Date: 8th May 2026
Reference: R10145-2 Rev 1

Re: Baldock Street, Royston – Planning Condition 18

2.0 Response to Condition 18

FIGURE 1 – COMMERCIAL UNIT

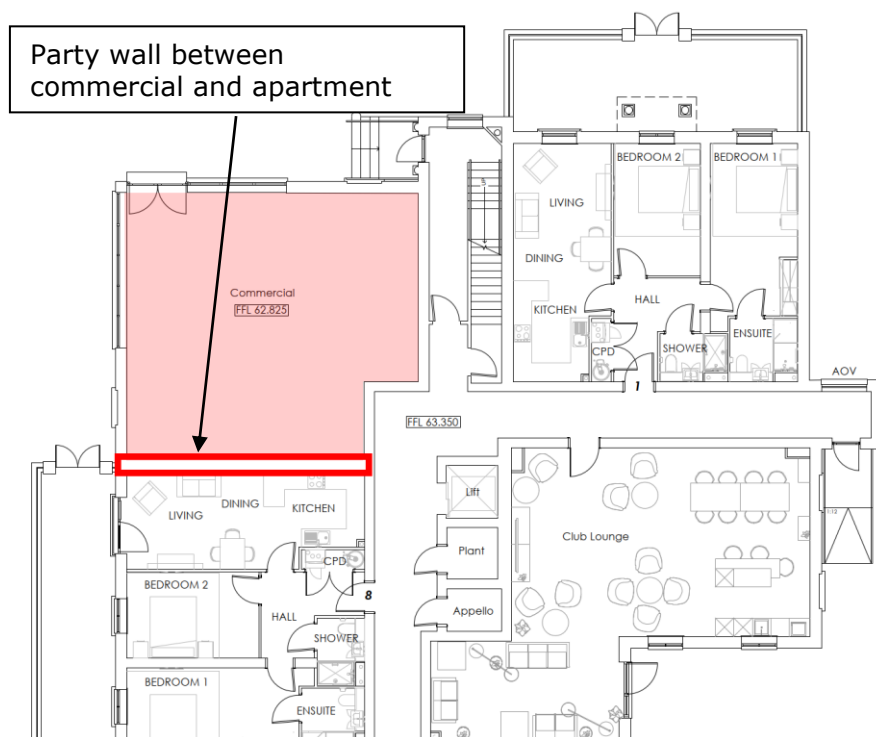
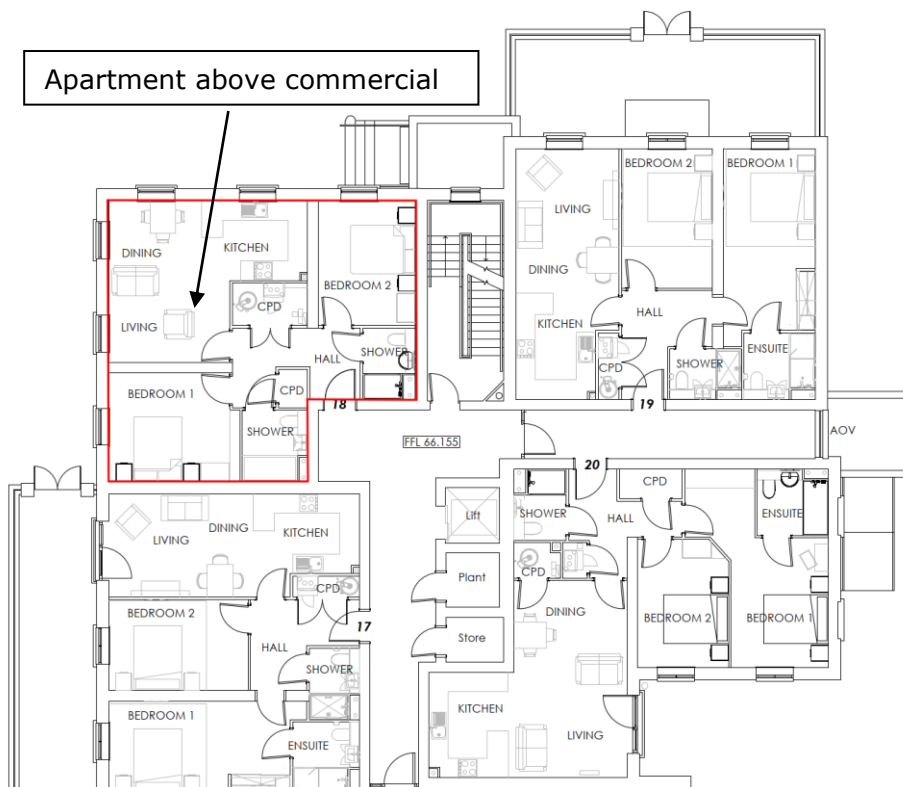
- 2.10 The planning noise assessment recommends that the party floors and party walls separating residential properties from the ground floor commercial unit be specified and built to achieve a minimum sound insulation performance of 55 dB $D_{nT,w} + C_{tr}$, i.e 10 dB better than the minimum Part E requirements.

- 2.11 The location of the commercial unit in relation to the apartments is shown in Figure 1.
- 2.12 The separating floor above the commercial unit will be constructed from screed on rigid insulation on top of precast concrete planks. To achieve the required sound insulation performance, a ceiling shall be provided in the commercial unit as per the below overall construction:

2.13 The cavity masonry party wall between the commercial unit and apartment 8 shall include an independent lining on the apartment side of the party wall, as per the below overall construction:

- Minimum 47mm flow screed
 - 55mm rigid insulation
 - 150mm precast concrete planks (minimum mass per unit area 300 kg/m²)
 - Minimum 100mm cavity
 - 50mm mineral wool (minimum 33 kg/m³) laid above the ceiling

- 2 x 12.5mm high density plasterboard (e.g. British Gypsum Soundbloc) installed on acoustic hangers (e.g. British Gypsum GAH1 / GAH2)

- 100mm concrete blockwork (minimum density 1450 kg/m³)
- 150mm cavity fully filled with Superglass Superwall 32
- 100mm concrete blockwork (minimum density 1450 kg/m³)
- Independent lining on the apartment side, comprising:
 - 2 x 12.5mm high density plasterboard (e.g. BG Soundbloc)
 - Minimum 50mm metal studs, offset from blockwork by at least 10mm
 - 50mm mineral wool (minimum 33 kg/m³) in the cavity

2.14 With good workmanship and favourable flanking conditions, the above party floor and party wall constructions are capable of achieving 55 dB D_{nT,w} + C_{tr} in line with the recommended criterion.
